Addendum No. 2

RFT 24-061 Gymnasium Addition - Glenview Public School

ADDENDUM #1

Project	Glenview PS Gym Addition	Project No.	2314
Location	143 Townsend Ave., Burlington, ON	Date of Issue	2024 05 17
Owner	Halton District School Board	File	2314/7.1.3

Drawing Title:
DOOR SCHEDULE & DETAILS, WINDOW & CW ELEVATIONS

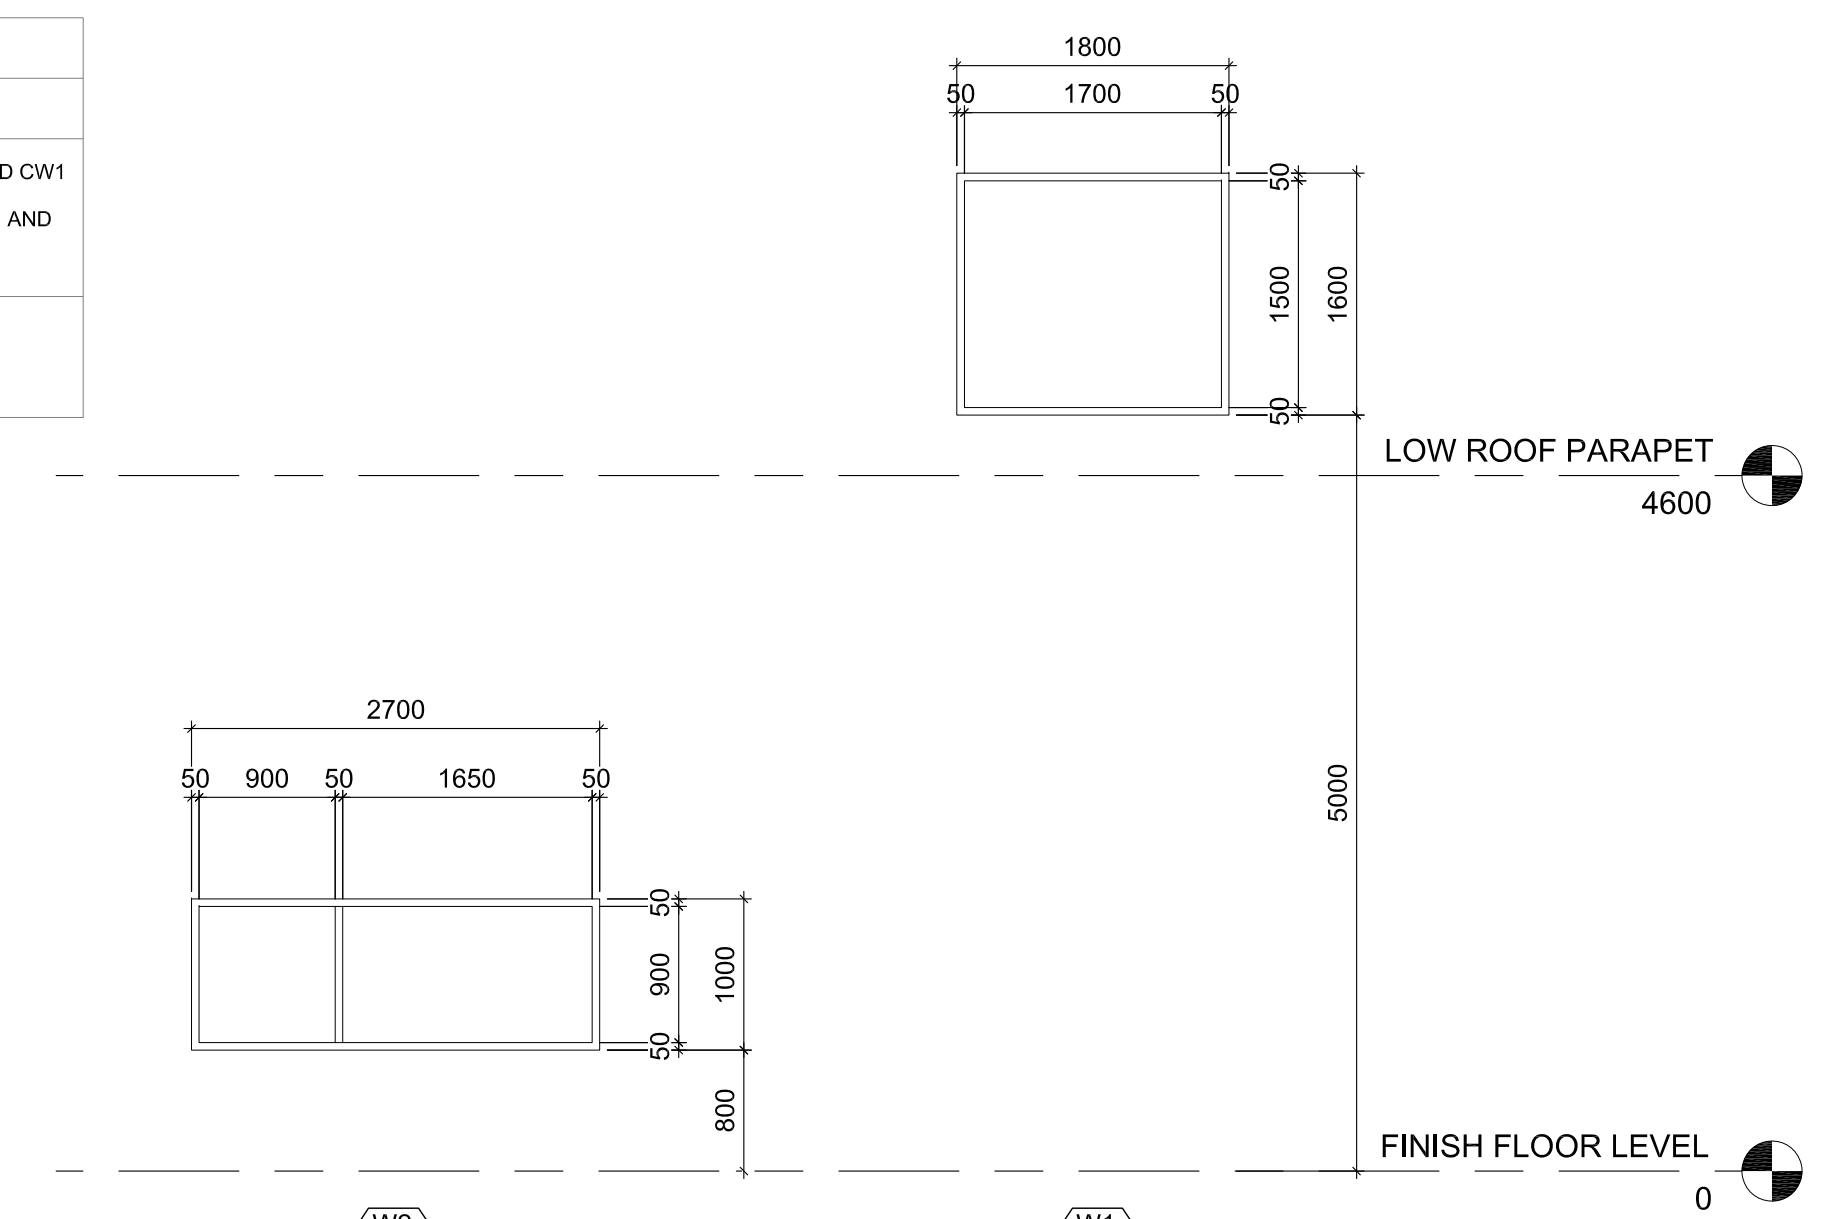
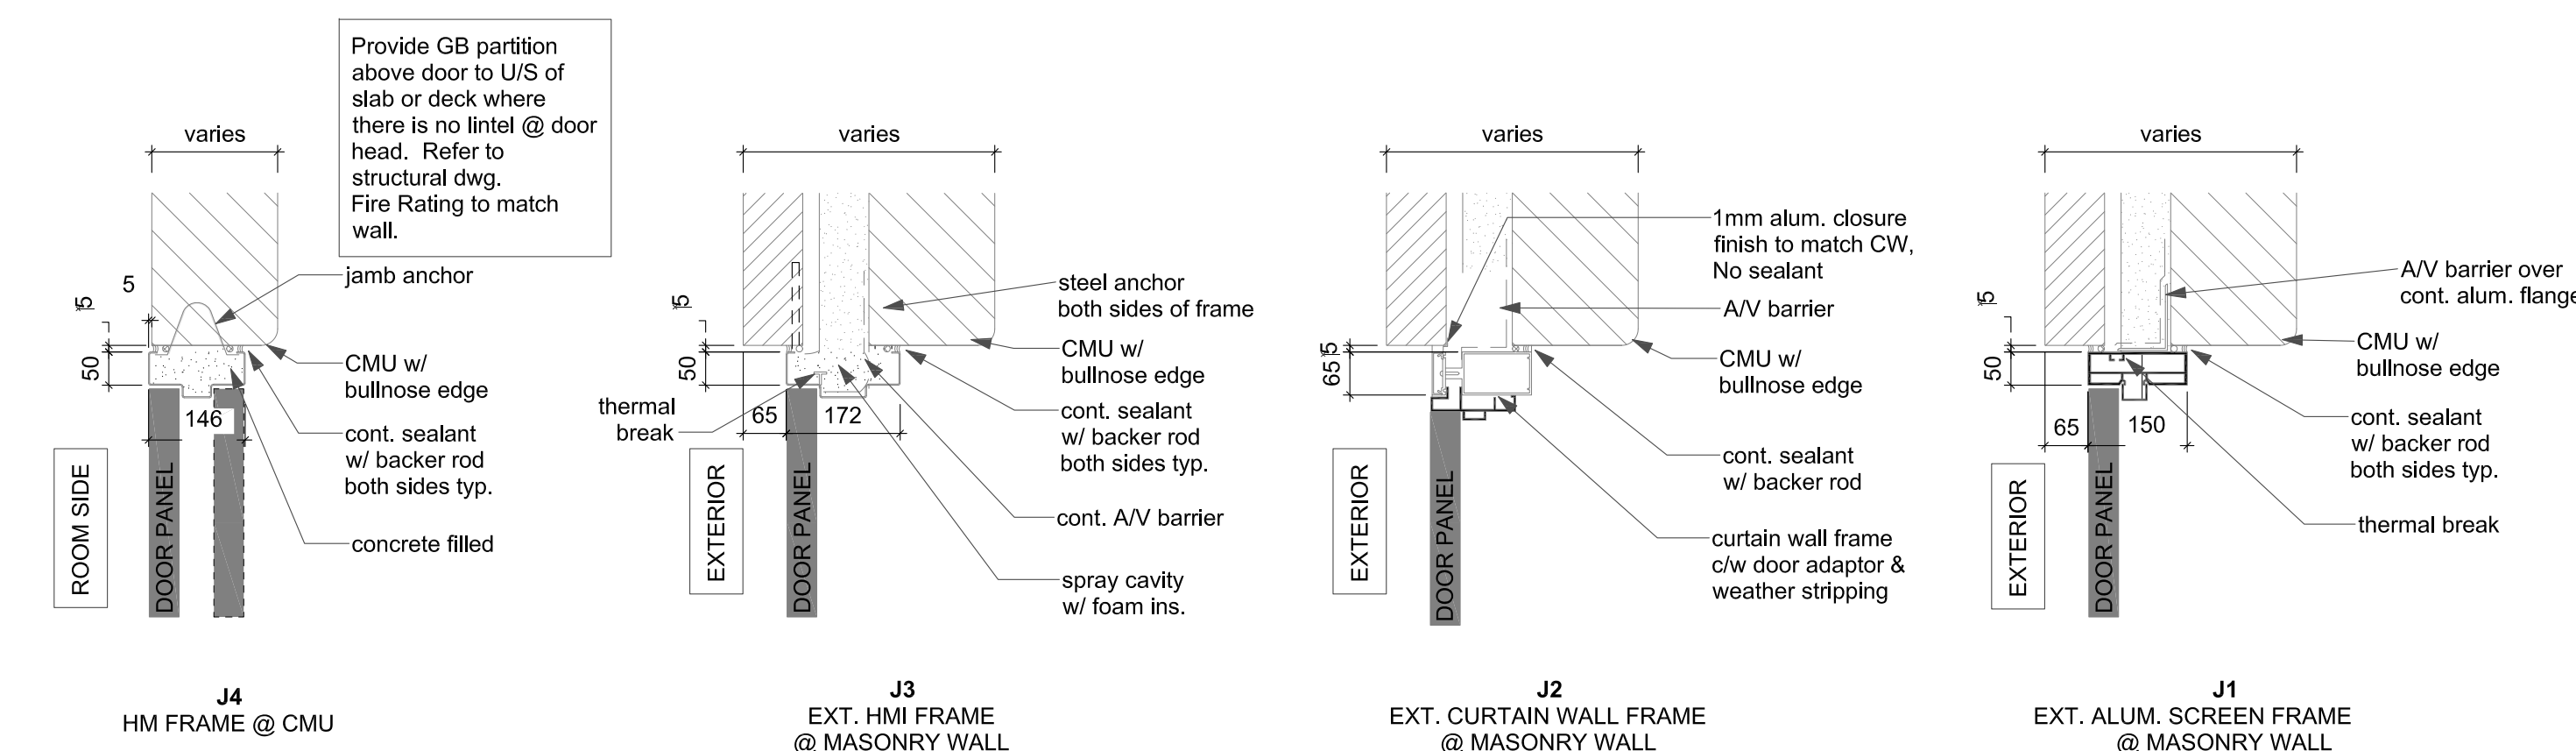
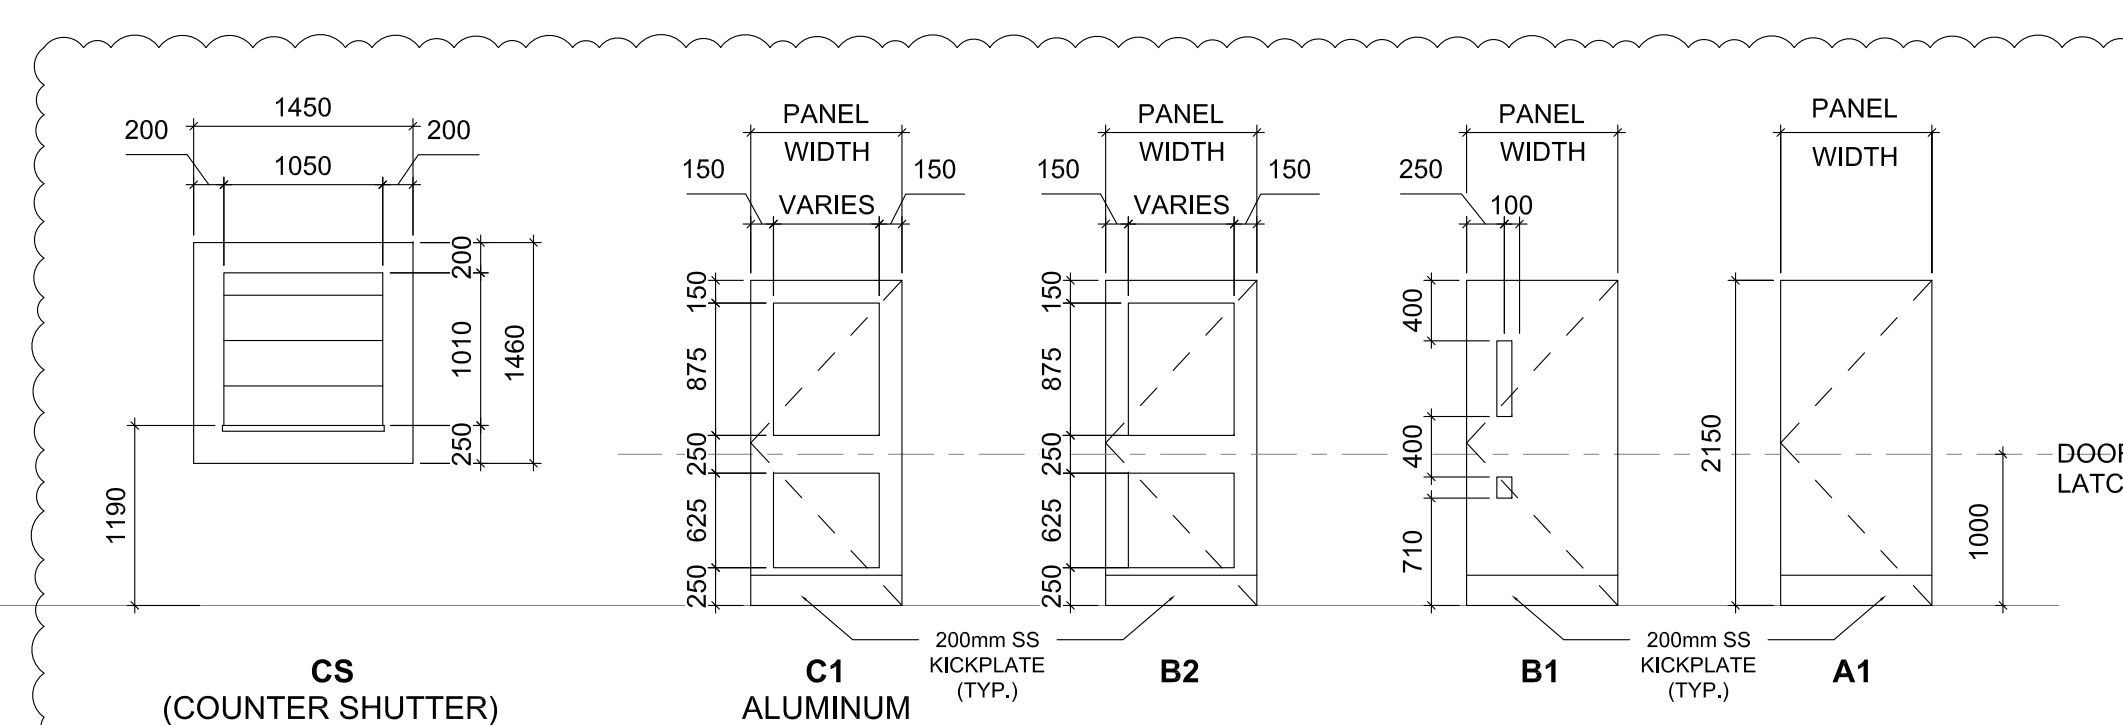
A1-11 DRAWING A901 DOOR SCHEDULE & DETAILS, WINDOW & CW ELEVATIONS

- .1 Replace Drawing with the attached Revision No. 3.
- .2 Drawing reissued to update Door Schedule and Door Types.
